## SFMTA - TASC SUMMARY SHEET

**RE: Application for Major Encroachment Permit  
Stevenson Street, West of Third Street, San Francisco, California 94103  
Assessor's Block 3706 / Adjacent Lot Nos. 061, 062, 064, 278, 074, 275, 276, 127 - 274**

*Note to File Date:* February 23, 2021  
*Case No.:* 2008.1084E  
*Project Title:* 706 Mission Street, The Mexican Museum and Residential Tower Project, Stevenson Street Streetscape Improvements  
*Zoning:* C-3-R (Downtown - Retail) Use District  
400-I Height and Bulk District  
*Block/Lot:* 3706/123  
*Project Sponsor:* Kristin Gonsar, 706 Mission Street Co. LLC,  
[kgonsar@706missionco.com](mailto:kgonsar@706missionco.com) or (415) 593-1288  
*Staff Contact:* Debra Dwyer, Principal Environmental Planner  
[Debra.Dwyer@sfgov.org](mailto:Debra.Dwyer@sfgov.org) or (628) 652-7576

SHEET: C3.02  
SHEET DESCRIPTION: SITE PLAN - EAST

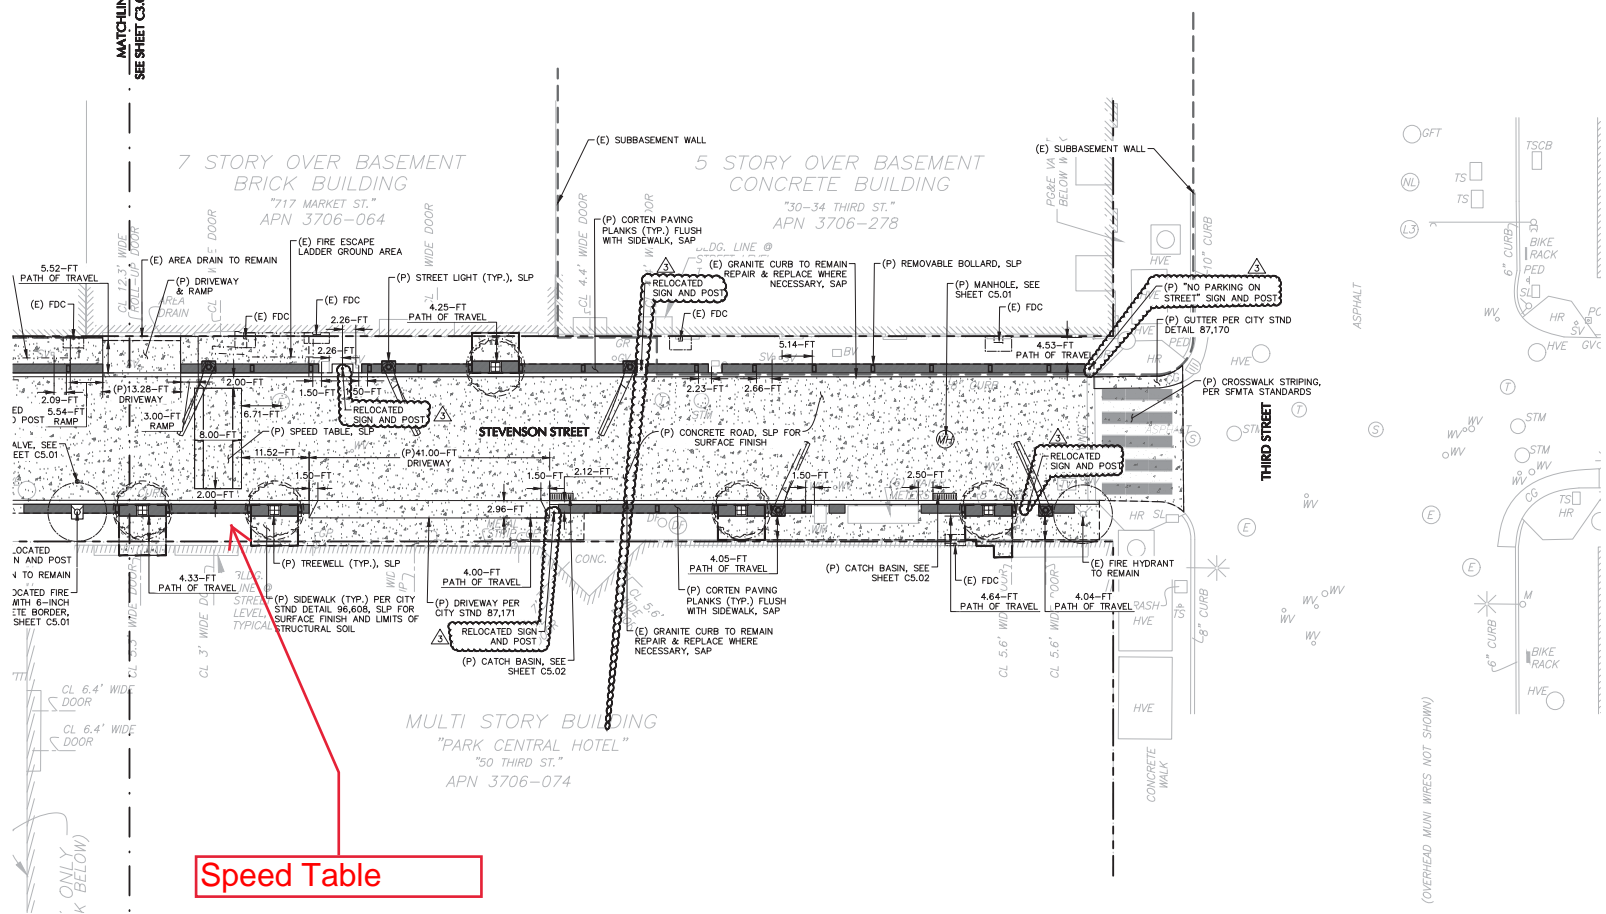
Apologies for the delay. I thought we spoke on the phone about this project. The SFFD requires a 3' minimum clearance around FDC's and a 5' minimum clear circumference around Fire Hydrants. Since this is public right of way, would the proposed speed tables be presented at the SFMTA TASC meeting? Either way, the SFFD would not object to the proposed speed tables at Stevenson Alley. Please contact me if you have any questions.

CONTRACT NO.	
DRAWING NO.	STR-7687
FILE NO.	
REV. NO.	3

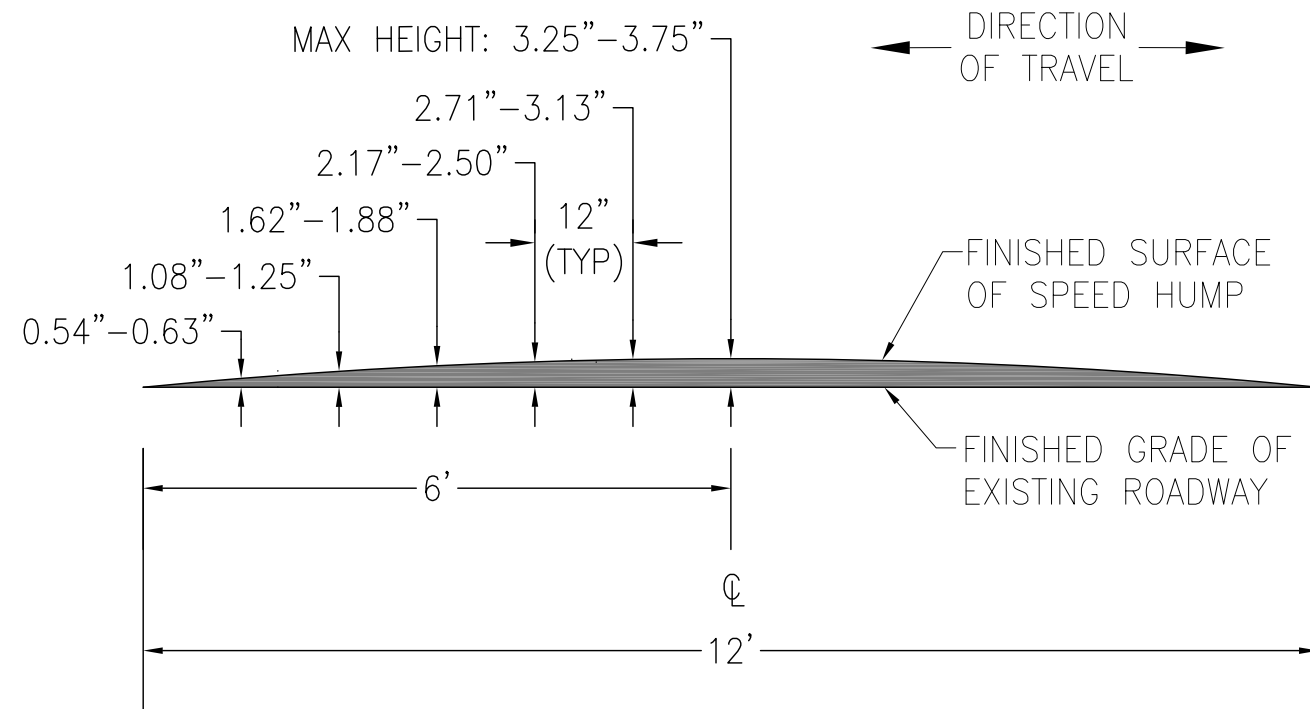
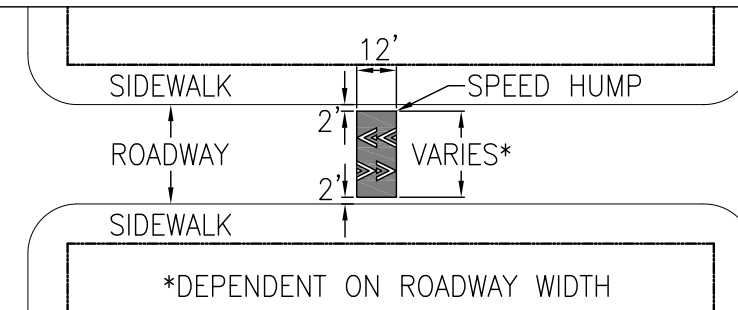
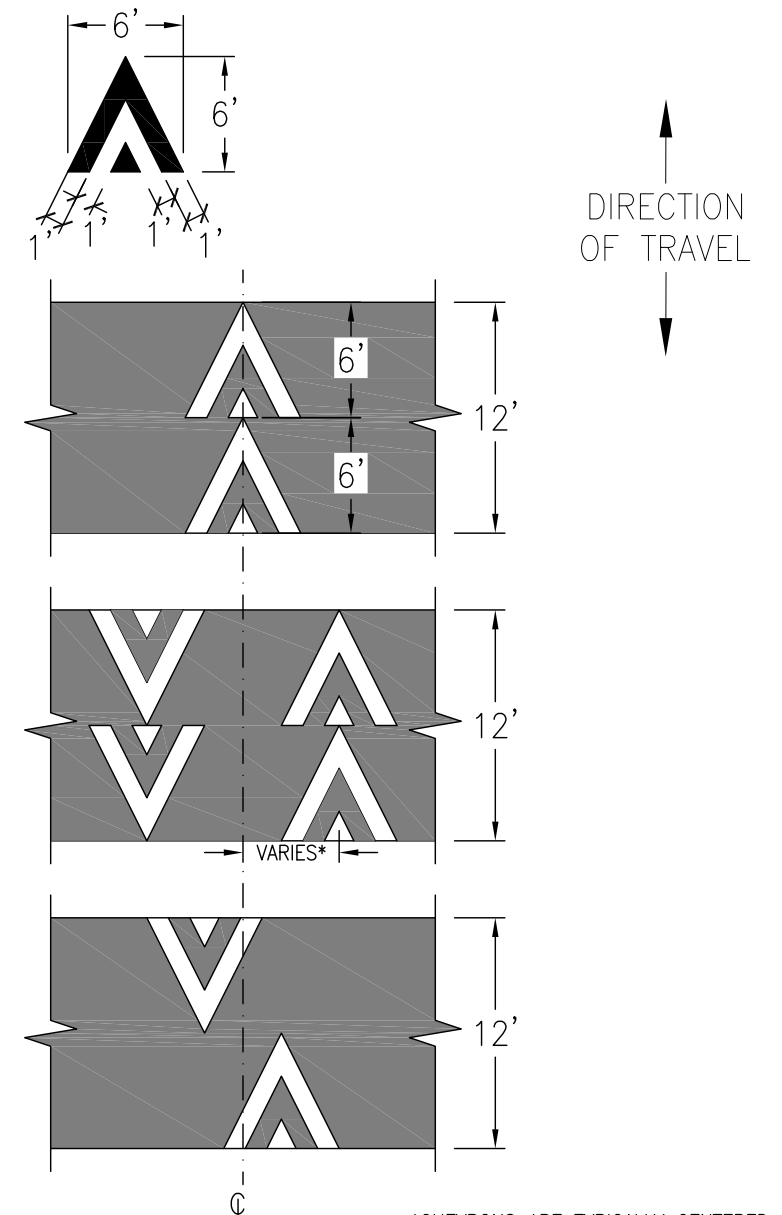
The SFFD has no issues with the SFMTA Speed Table specs.
